**REVISION E CHANGES = E**  
**(4 CHANGES NOTED ON DRAWING)**

| CUSTOMER APPROVAL (SIGNATURE REQUIRED): |            | TITLE<br>TECHTOWER,<br>PAYMENT DEVICE ARM,<br>TO MOUNT OPEN HOLE SWIVEL STAND,<br>ROTATING CLAMP |
| DATE                                    |            | SIZE C DWG. NO. 367-2009-01 REV. E SHEET 1 OF 1  |

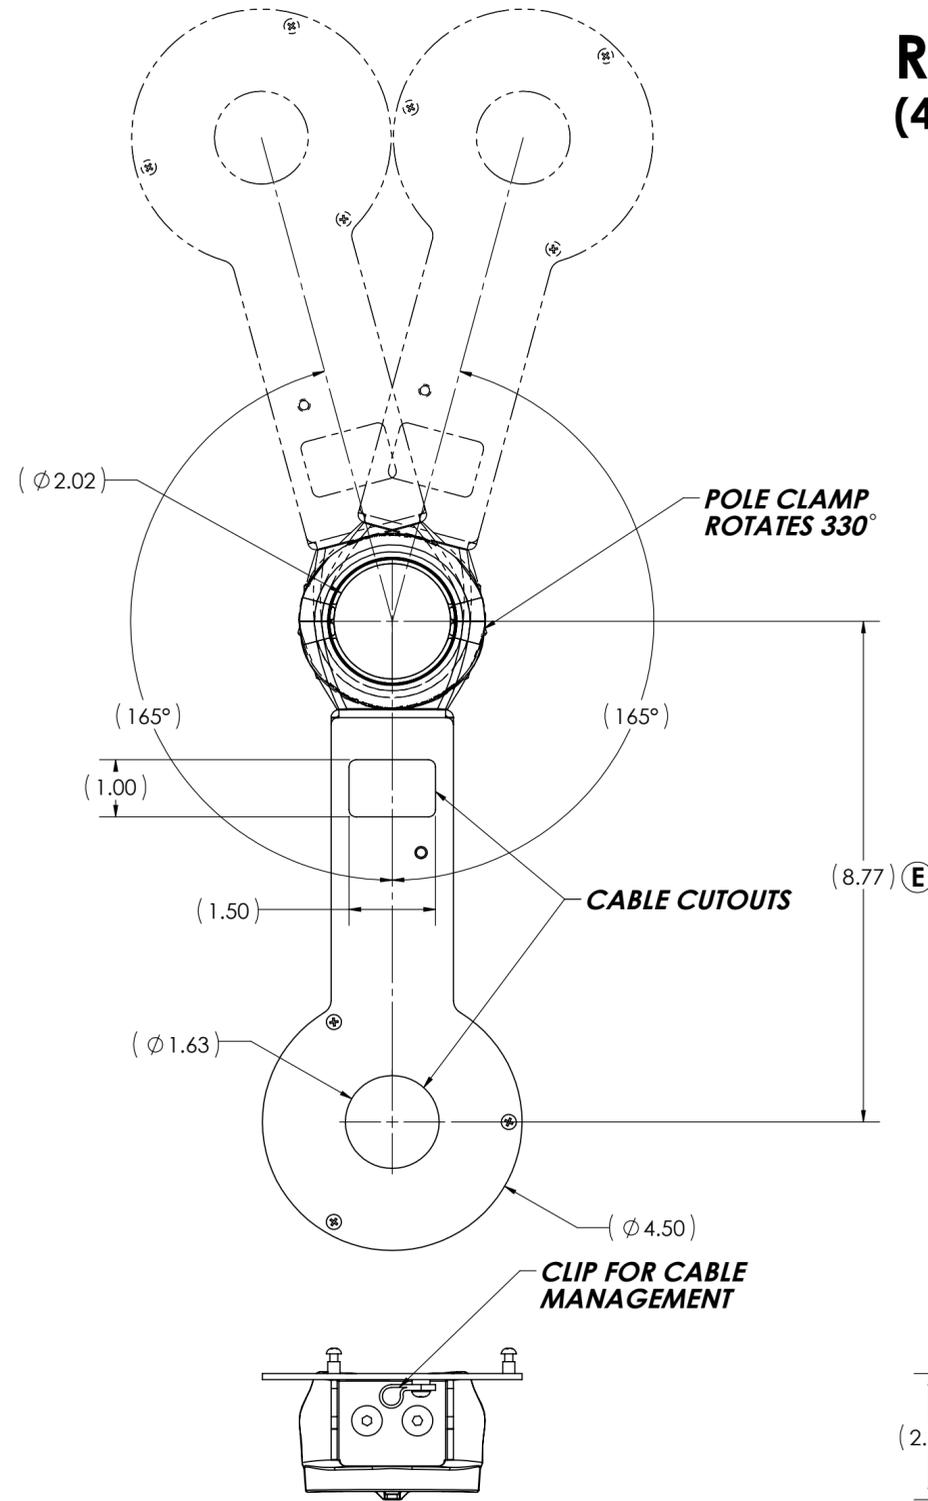
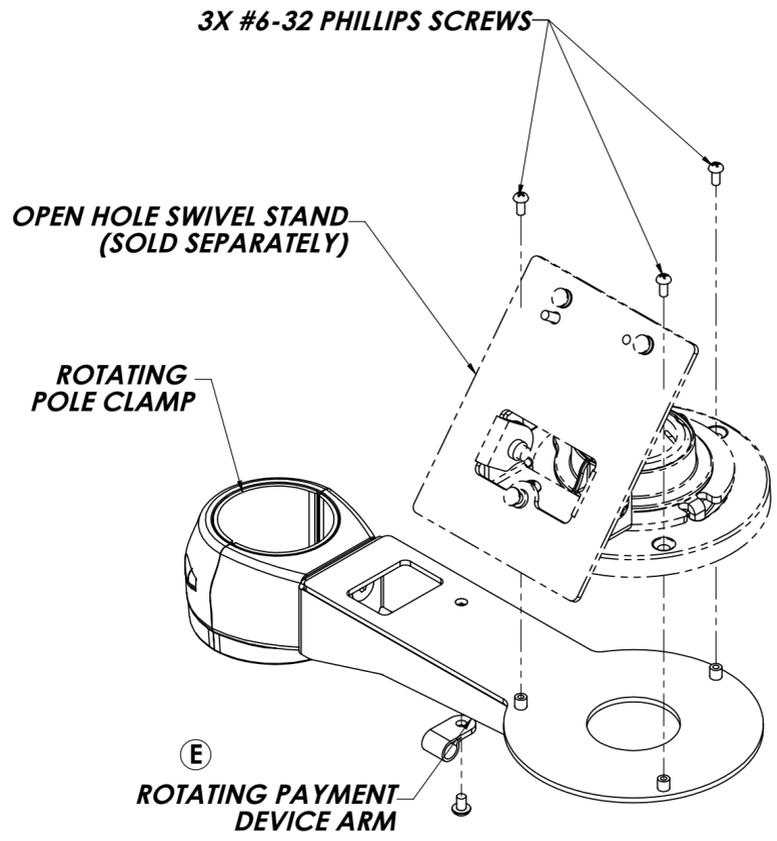
| REV. | DESCRIPTION  | DATE     | BY  | CHK'D |
|------|--|----------|-----|-------|
| E    | REVISED ROTATING PAYMENT DEVICE, DIM 7.38 WAS 6.54, 11.02 WAS 10.18, 8.77 WAS 7.93   | 04/07/14 | JEB |       |
| D    | REVISED ROTATING PAYMENT DEVICE ARM TO NEW DESIGN, 330° ROTATION WAS 180°, DIM 2.21 WAS 2.34, 6.54 WAS 6.65, ADDED DIM 7.93                  | 01/22/14 | JEB | RKT   |
| C    | REVISED ROTATING POLE CLAMP TO NEW DESIGN, 330 ROTATION WAS 180 DIM 165 WAS 90, 10.18 WAS 10.47, 2.34 WAS 1.83, 1.54 WAS 1.68, 6.65 WAS 6.95 | 12/02/13 | SY  |       |
